RAI-7

Description of Deficiency

The information in TR Section 2.6.2 does not meet the applicable requirements of 10 CFR 40.41(c), using the review procedures in Section 2.6.2 and acceptance criteria in Section 2.6.3 of the SRP.

Attachment 2
North Platte Decree Figures
Areas Not Hydrologically Connected
April 13, 2004

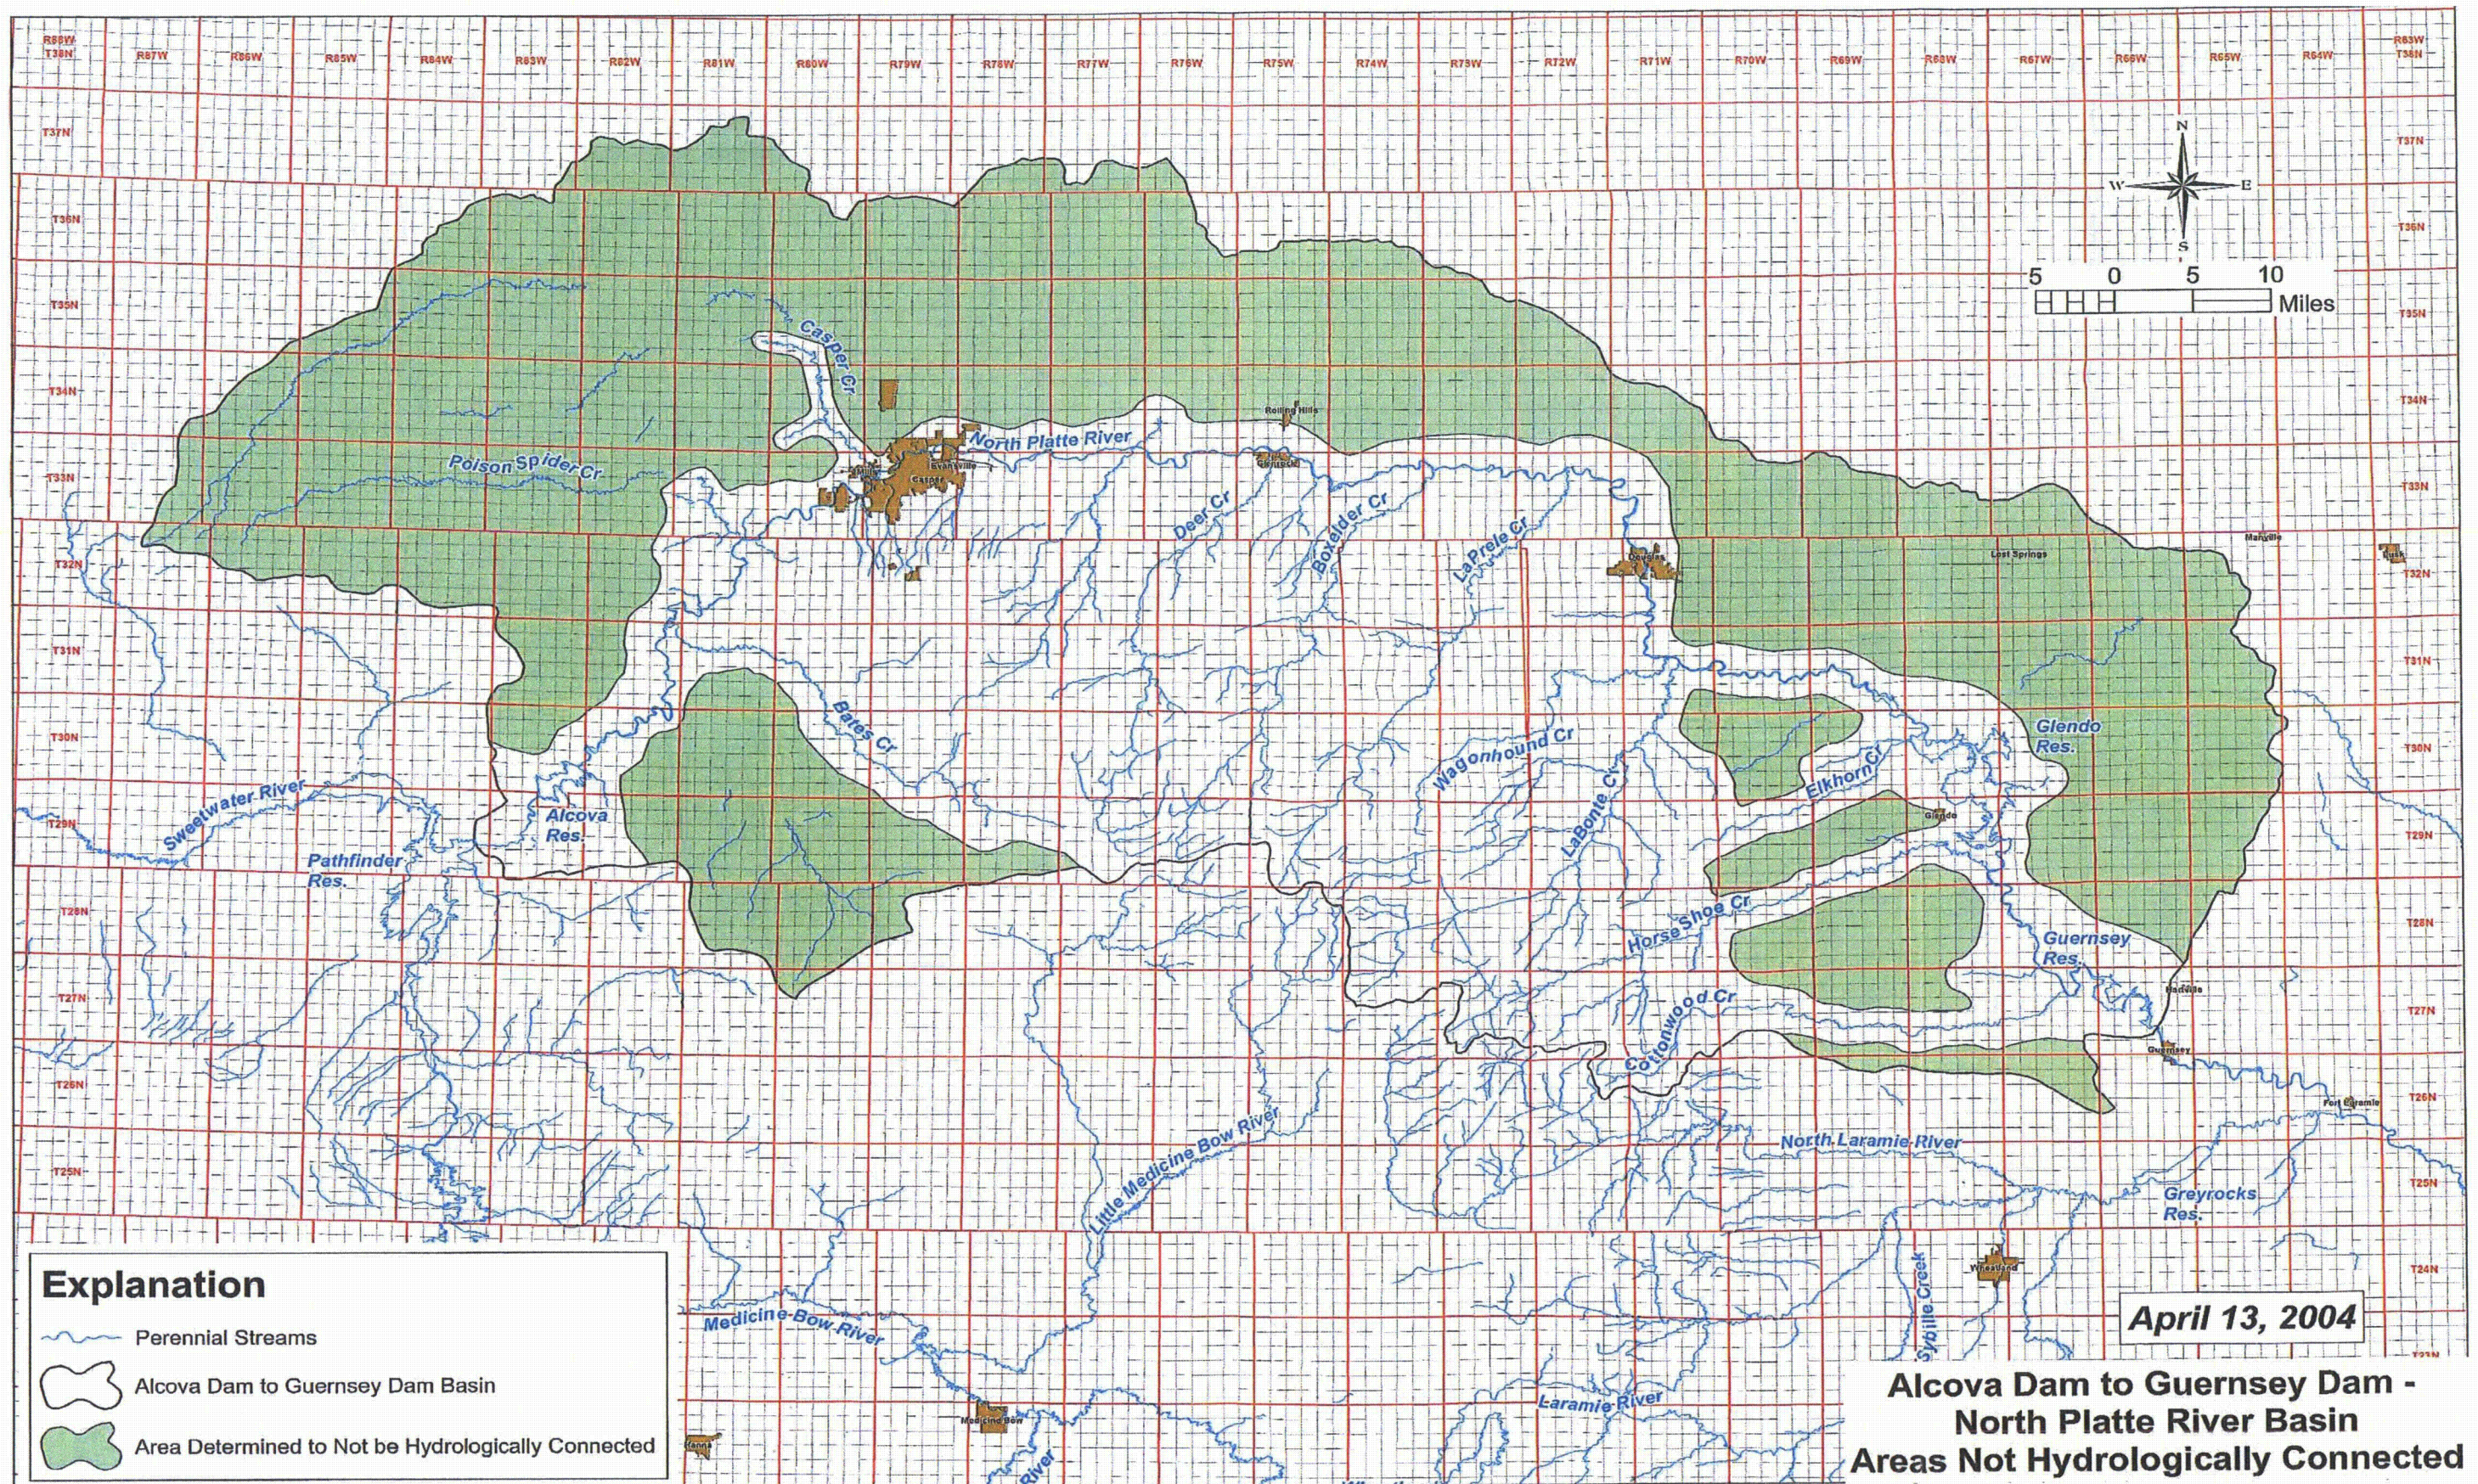
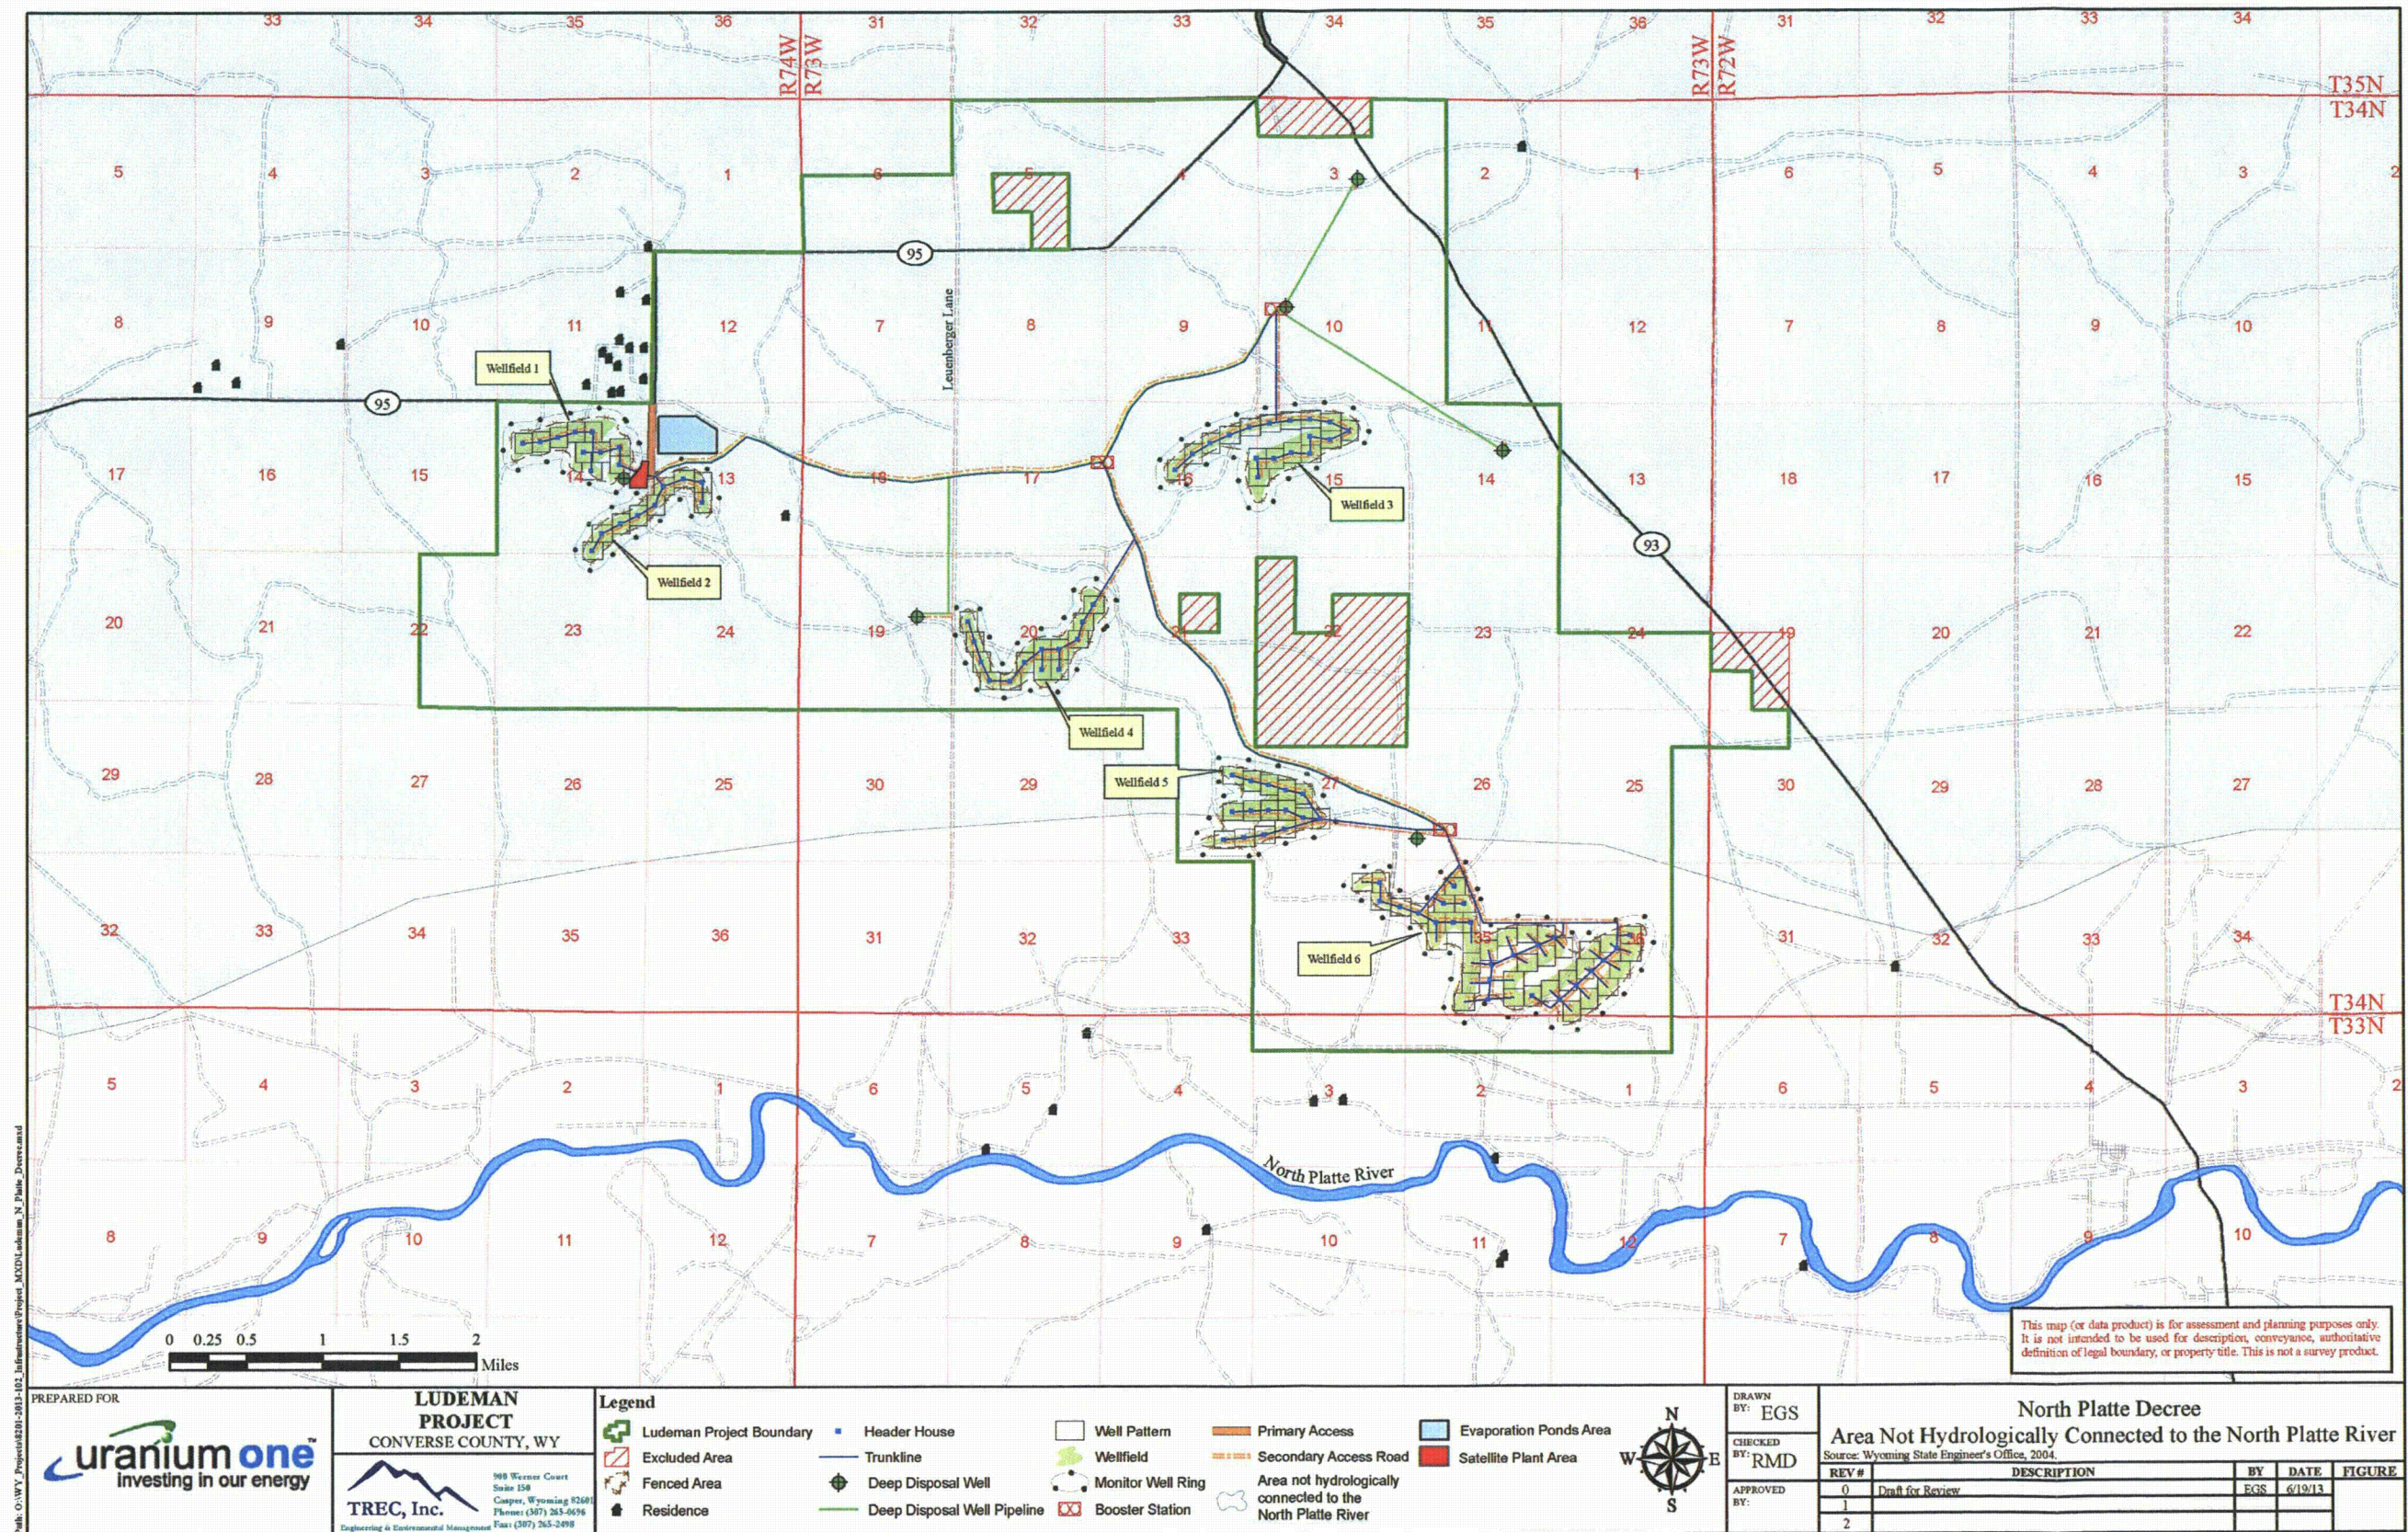
On November 13, 2001, the Supreme Court of the United States issued the Modified North Platte River Decree which addressed water use from the North Platte River. In this decree, portions of the North Platte watershed are identified as hydrologically connected to the North Platte River. Within these regions surface water and ground water use for irrigation and other purposes is strictly controlled by a court order. Staff's review of the regional map (<https://sites.google.com/a/wyo.gov/seo/documents-data/maps-and-spatial-data>) for hydrologically connected areas near the North Platte River showed that the Peterson Satellite is located within the hydrologically connected region. Therefore all water use at this satellite, whether surface or ground water, must be approved by WSEO to meet the requirements of the decree. Any evaporation or surge ponds must also meet the terms of the decree. The TR does not include a discussion of the decree in its characterization of ground water or surface water or the implications for the safety of operations at the Peterson Satellite if water use is limited or restricted. Staff cannot provide reasonable assurance of the safety of operations without this information.

- A. A description of the Modified North Platte River Decree and implications for water use at Peterson Satellite;*
- B. Assurance that the water use required for production and restoration at the Peterson Satellite will be evaluated and approved as required under these orders. This water use includes wells and all surge /evaporation ponds; and*
- C. A commitment that if any changes to the wellfield design, ponds, or water use are incurred by the WSEO under this order before operations begin or during operations, Uranium One must inform NRC, so that a safety evaluation of these modifications may be made.*

Uranium One performed an evaluation of the Wyoming State Engineer's Office (SEO) stream flow depletion from groundwater withdrawals based upon provisions of the Modified North Platte Decree and the Platte River Recovery Implementation Program (PRRIP), i.e. the "28:40" connection criteria (see Attachment 1 SEO Hydrological Connection – 28:40 criteria). This criterion established methods designed to assess for the potential of a "hydrological connection" related to groundwater usage on stream flow depletion. Therefore, several criteria's were utilized to initially screen for potential

An assessment of the hydrogeologic setting was conducted for proposed Well Field No. 5. This proposed well field is located at an approximate distance of 10,400 feet from the North Platte River. The proposed ISR wells will be completed at an average depth exceeding 300 feet bgs. From pumping tests conducted near the proposed Well Field No. 5, the aquifer systems are considered to be confined, since there was no drawdown response detected in monitoring wells completed in the overlying and underlying aquifer systems. Consequently, it could be assumed that these aquifer systems, due to their depth and confined nature, would not be connected to or contribute any meaningful volumes groundwater recharge to the North Platte River.

Likewise, an assessment of the hydrogeologic setting was conducted for proposed Well Field No. 6. This proposed well field is located at an approximate distance of 5,000 feet from the North Platte River. The proposed ISR wells will be completed at an average depth exceeding 300 feet bgs. From pumping tests conducted in the proposed Well Field No. 6, the aquifer systems are considered to be confined, since there was no drawdown response detected in monitoring wells completed in the overlying and underlying aquifer
